Re: Comments and response to Clean Heat Standard potential study draft results

I am writing in response to the Department of Public Service's (PSD's) request for comment on NV5's Clean Heat Standard potential study draft results. Since this information is also relevant to pacing considerations for the Clean Heat Standard, the PSD suggested that I also file this letter with the PUC via ePUC.

Vermont annual heating degree days, 1990–2023

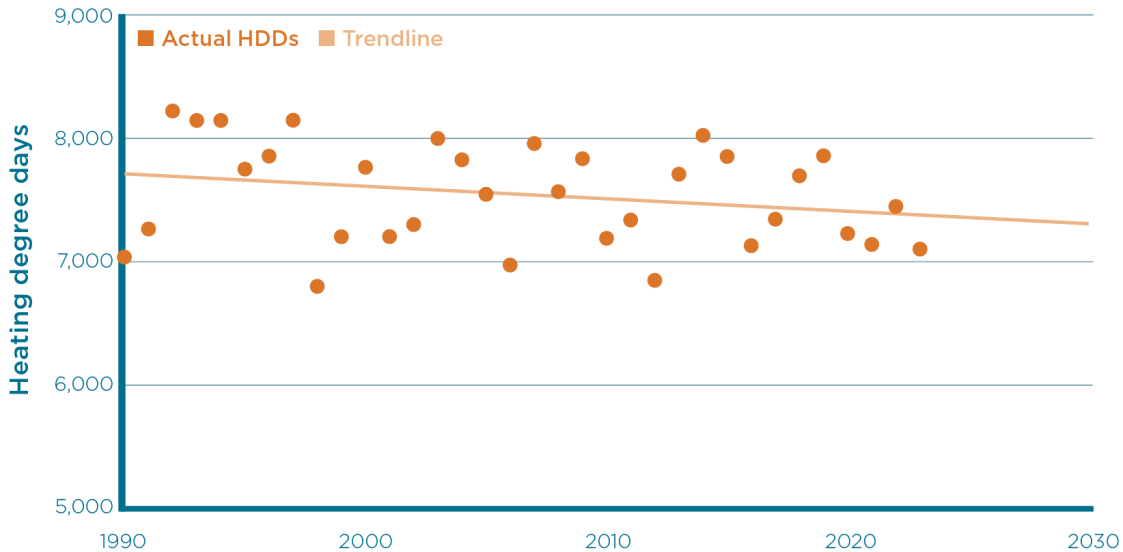
C) NV5 baseline assumptions do not account for warming VT winters

During a July 30 meeting with PSD staff held at the request of TJ Poor and Matthew Bakerpoole, I learned that NV5 is not incorporating declining heating degree days into their modeling.

In its recent paper “Analyzing changes in fossil heating fuel use in Vermont, 2018 – 2023”⁶, EAN included population-weighted heating degree day data for Vermont, accessed from the National Oceanic and Atmospheric Administration (NOAA) for 1990 to 2023.⁷ While there is year to year variability, incorporating a regression trend line shows that **the average number of heating degree days in Vermont has declined by about 4% from 1990 to 2023, or roughly an average decline of 0.13% each year.**⁸

Warming winters (or fewer heating degree days) result in lower heating loads and therefore contribute to declining fossil fuel use. As unfortunate as the reality of our warming winters may be, I do not think this physical reality should be ignored in modeling. Consider the opposite situation: would the PUC accept a Demand Resources Plan (DRP) from a distribution utility that failed to account for projected increases in summer electricity demand for cooling, due to increasing cooling degree days? If not, I would suggest that it is not appropriate to accept modeling that fails to incorporate the physical reality of warming winters in its projections for heating demand and related RCI emissions into the future.
